ADDENDUM NO. 4

**Section 504/UFAS Unit Reconfiguration at
Pressley Street High-rise Apartments
IFB#600-34-12 G-H-E-P**

October 17, 2012

1 REVISION TO E-1
SKE-1 N.T.S.

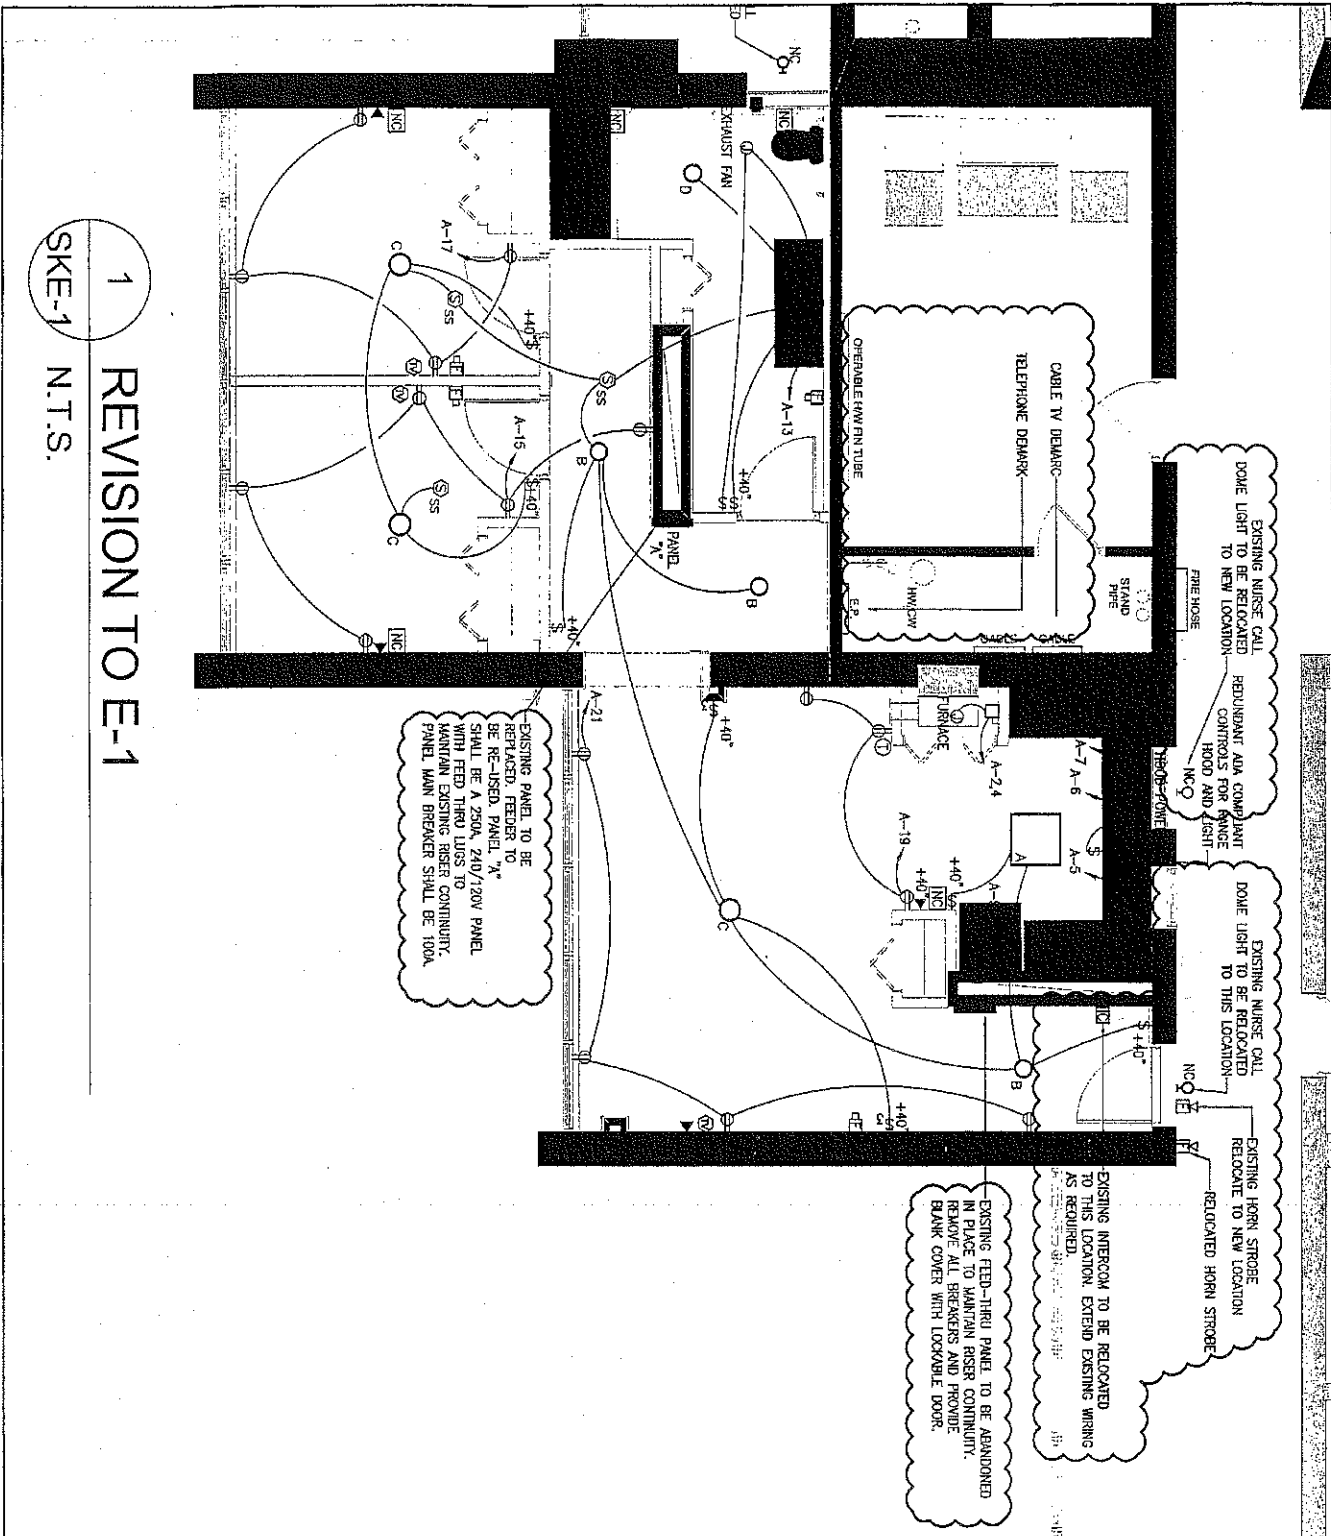
Question: Both panels in Unit #11 appear to be feed thru panels. How are we to keep the feed thru feeders in place after the removal of one (1) panel and replacing the other with a non-feed thru panel?

Question: I would like to know the connection point of the phone and cable system.

Answer: See attached sketch SKE-1.

Answer: See SKE-1 for demarcation points.

HVAC FLOOR PLAN

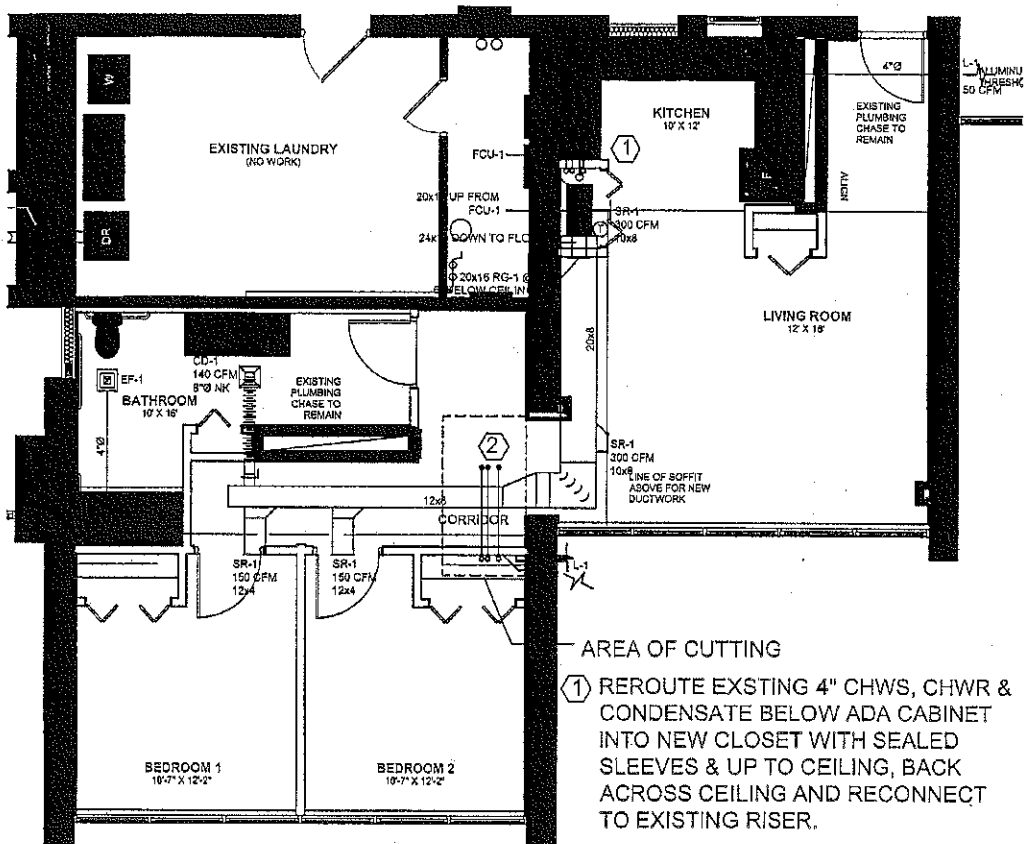
Question: How are existing pipes feeding the furnace units to be rerouted with the new plan configuration?

Answer: See attached sketch SKH-1.

- AREA OF CUTTING
- ① REROUTE EXISTING 4" CHWS, CHWR & CONDENSATE BELOW ADA CABINET INTO NEW CLOSET WITH SEALED SLEEVES & UP TO CEILING, BACK ACROSS CEILING AND RECONNECT TO EXISTING RISER.
 - ② CEILING BELOW WILL BE CUT AS SHOWN. H.C. SHALL CUT, REMOVE & PROPERLY DISPOSE OF WASTE. ROUTE EXISTING 4" CHWS, CHWR & CONDENSATE IN CEILING BELOW INTO NEW CLOSET UP TO CEILING BACK ACROSS CEILING AND RECONNECT TO EXISTING RISER. H.C. SHALL FINAL PATCH & PAINT ALL SURFACES TO MATCH EXISTING SURFACES.

Sheet No. **A2**
 Project #1232

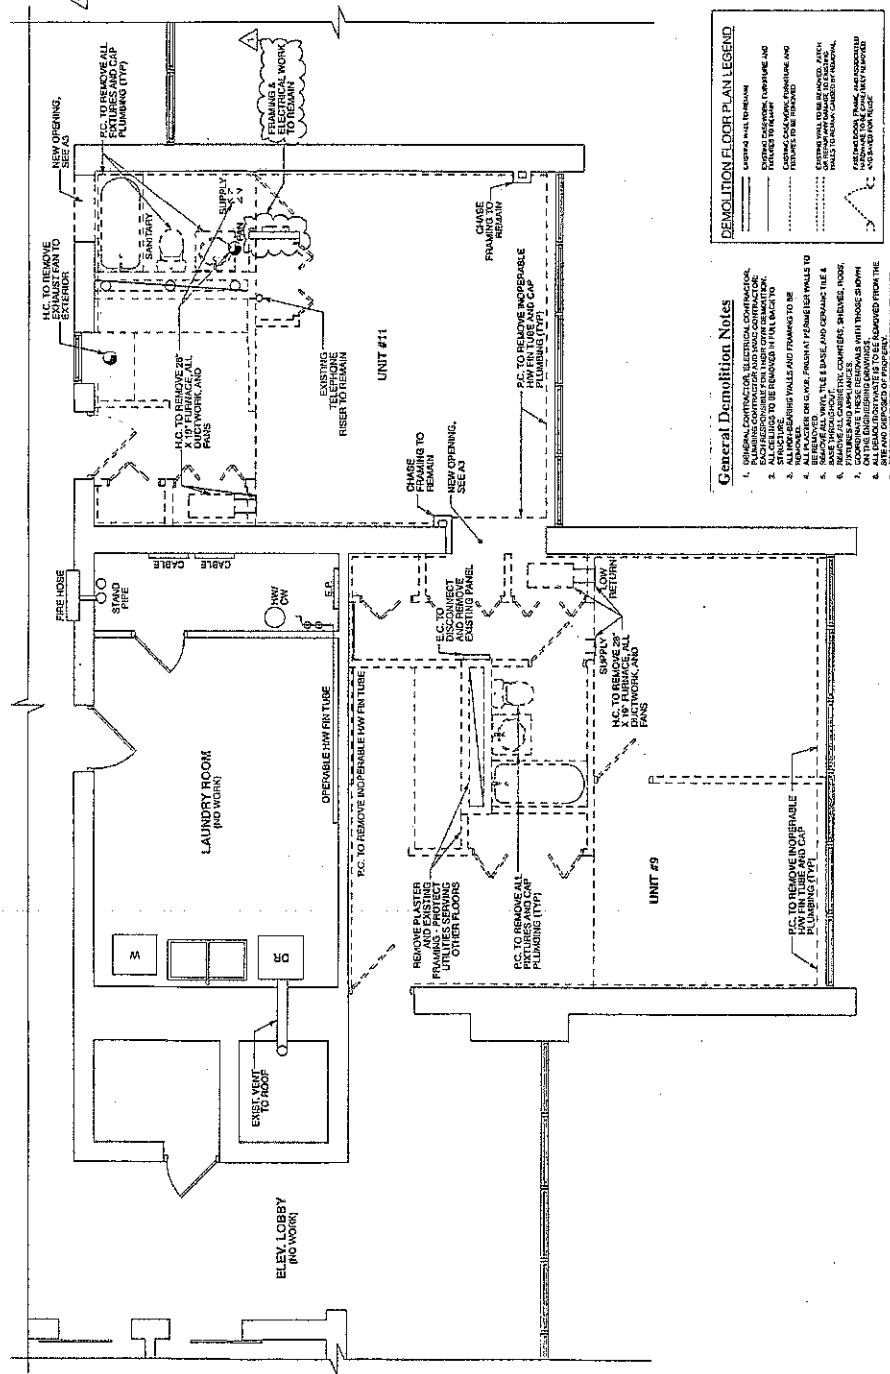
Question: If the existing electrical panel in Unit 1211 must remain as a pass through, can its current wall location remain?

Answer: The panel and wall can remain in their current location. Remove all plaster down to framing. Maintain 3'-0" minimum clear space between walls per article 4.4.3 of

UFAS Uniform Federal Accessibility Standards. See attached drawings Revised A2 and Revised A3.
